| <b>HANNAH RIDGE AT FEATHERGRASS<br/>         FILING NO. 5, 6 &amp; 7<br/>         OVERLOT GRADING AND EROSION CONTROL PLAN</b> |     |              |                 |

**HANNAH RIDGE AT FEATHERGRASS**  
 FILING NO. 5  
 STREET IMPROVEMENT PLANS  
 EQUINE COURT

HANNAH RIDGE AT FEATHERGRASS  
FILING NO. 5  
PROPOSED TRIBUTARY DRAINAGE IMPROVEMENTS

# Markup Summary

| DRAWN BY                                                                                                                       | KC  | (H) 1" = 50' | SHEET 2 OF 11   |

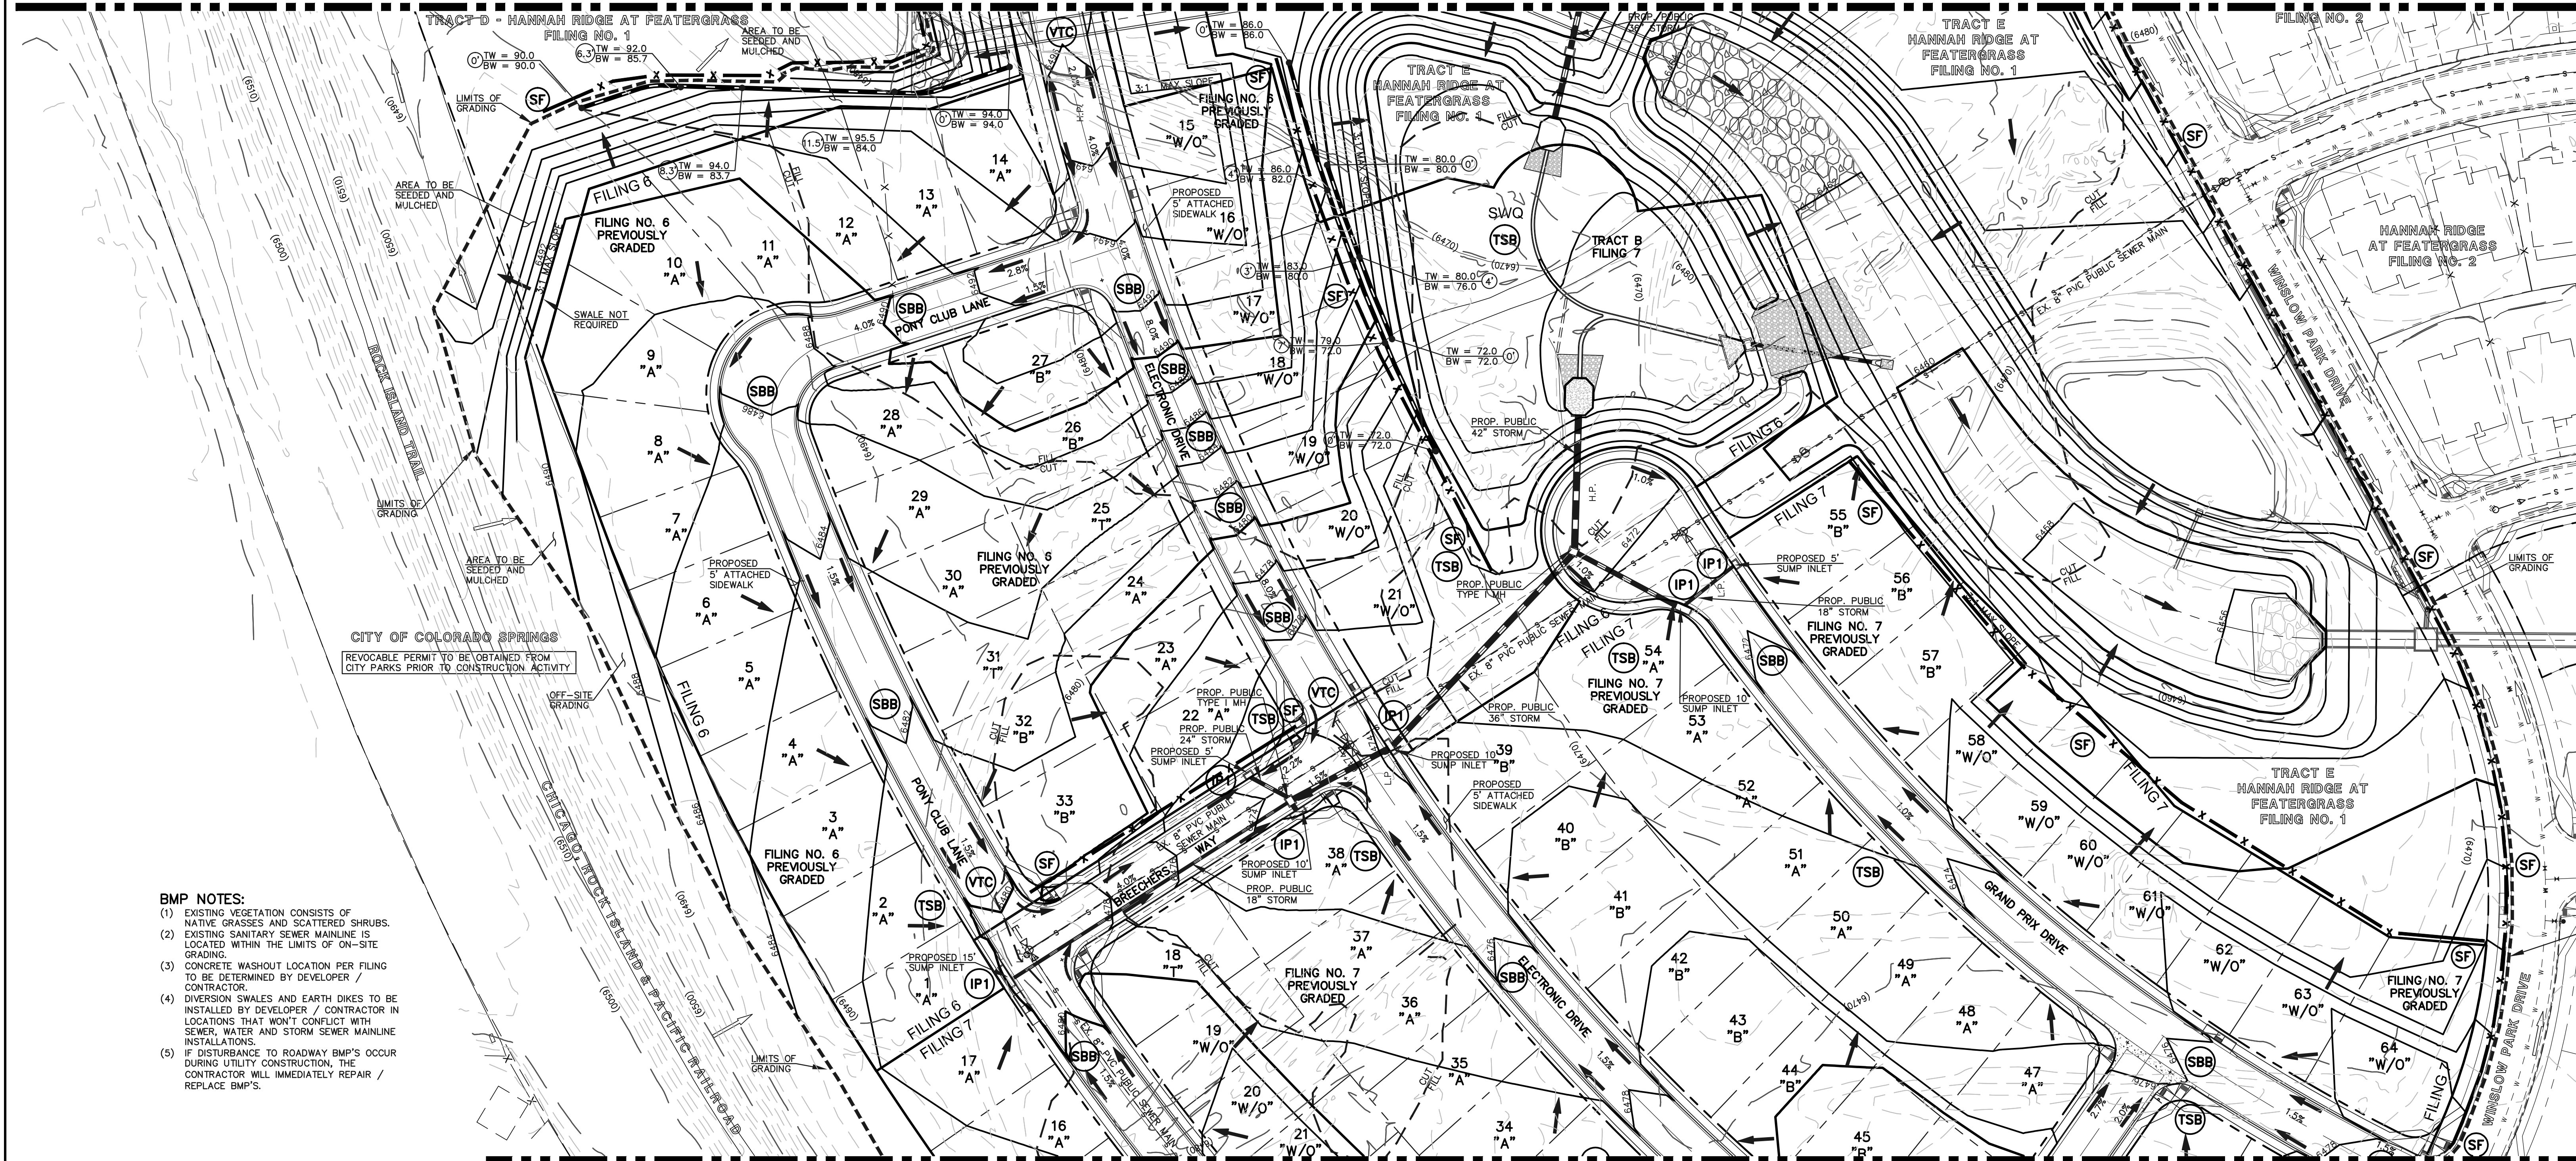
Comments on the version 1 review requested that the box culvert and the rip rap channel improvements (MVE plans) be included in the plan set. This set, Version 2, shows some box culvert details but no channel improvement details. Additionally the above grading contours show the box culvert and rip rap buried. So the previous comment still stands. Include the Rip Rap and Box Culvert plans with this set.

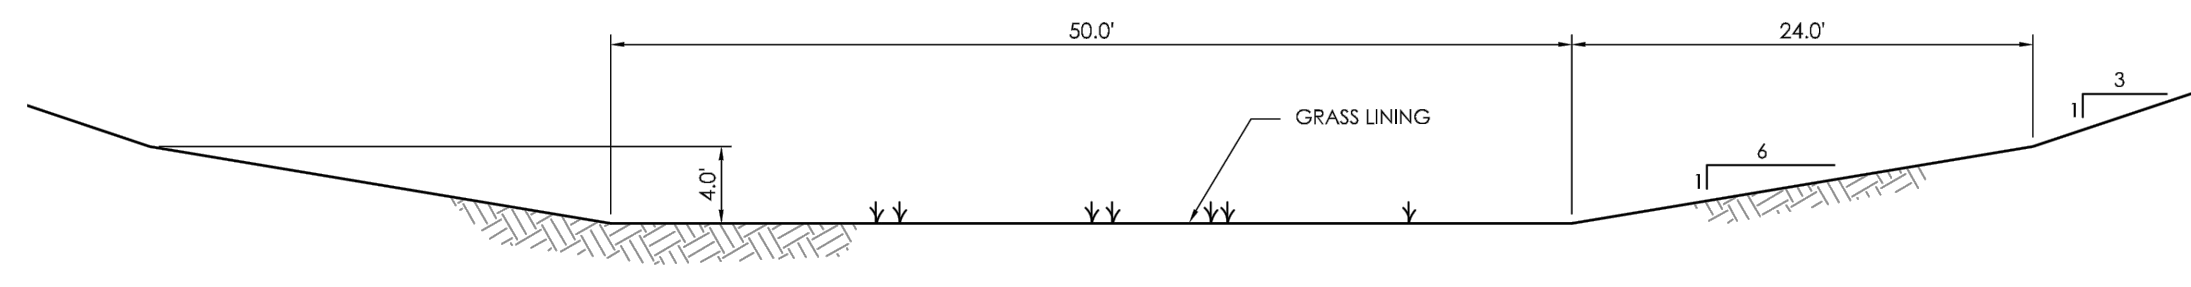
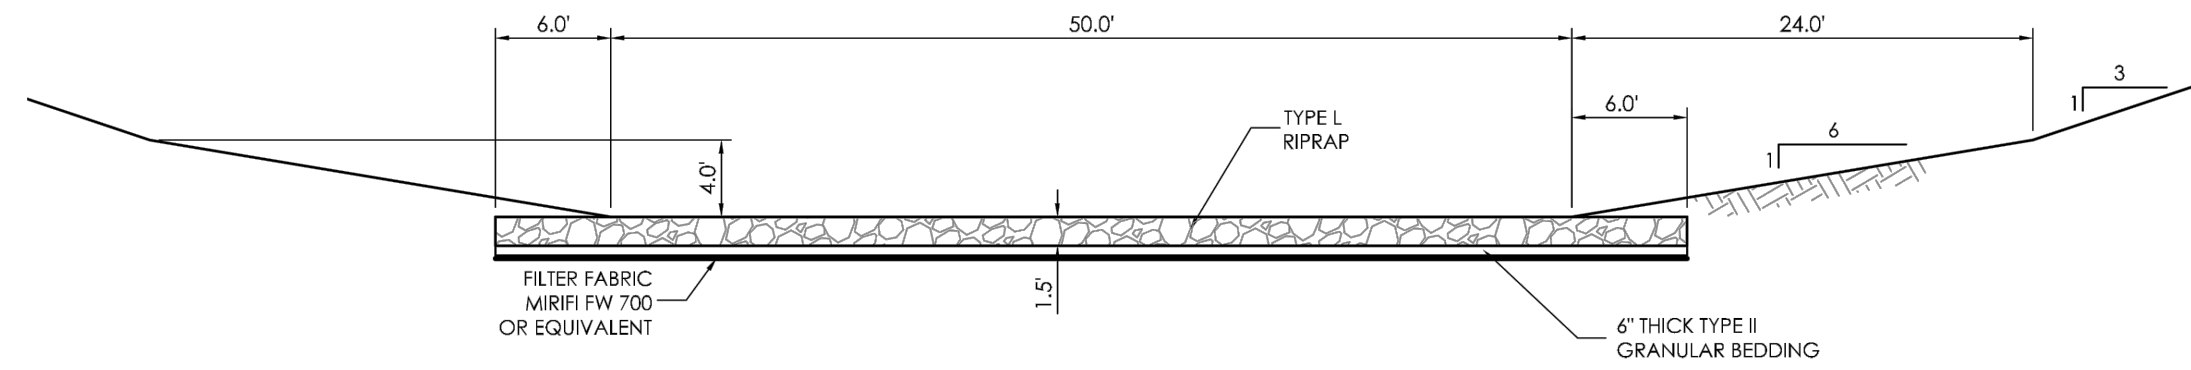
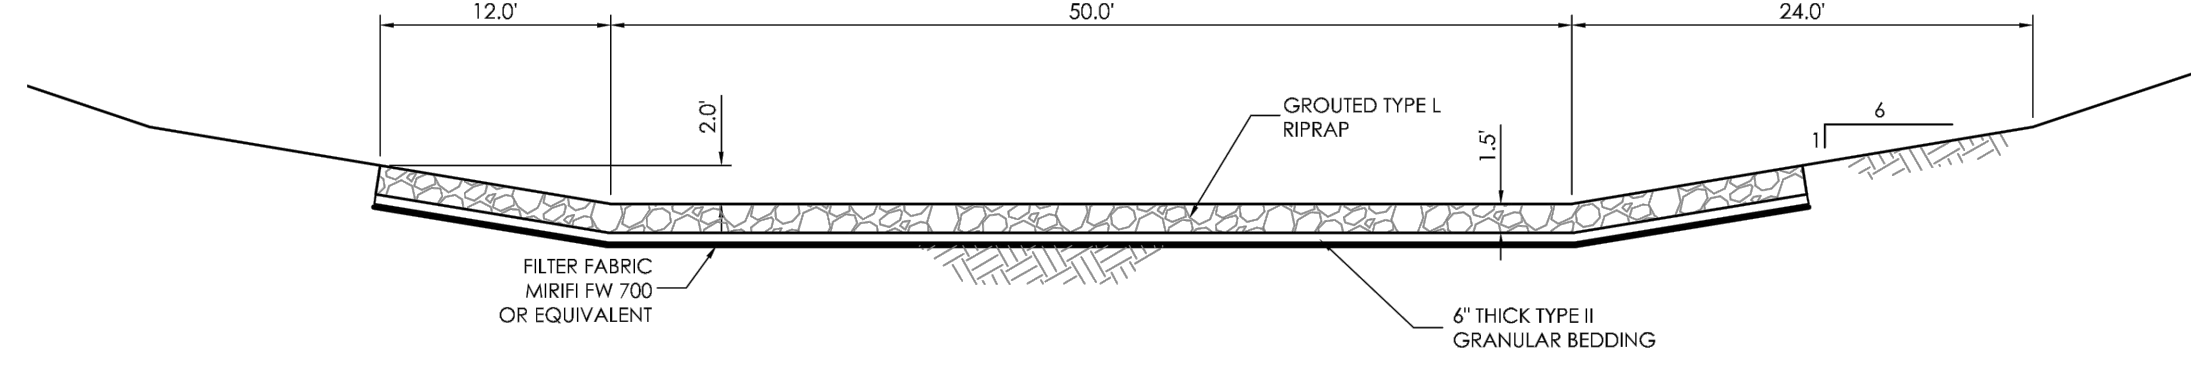
Call out Public Drainage easement.

The details of the SWQ outlet structure that were shown on sheet 10 of 11 on version 1, are no longer n this set. Please include them.
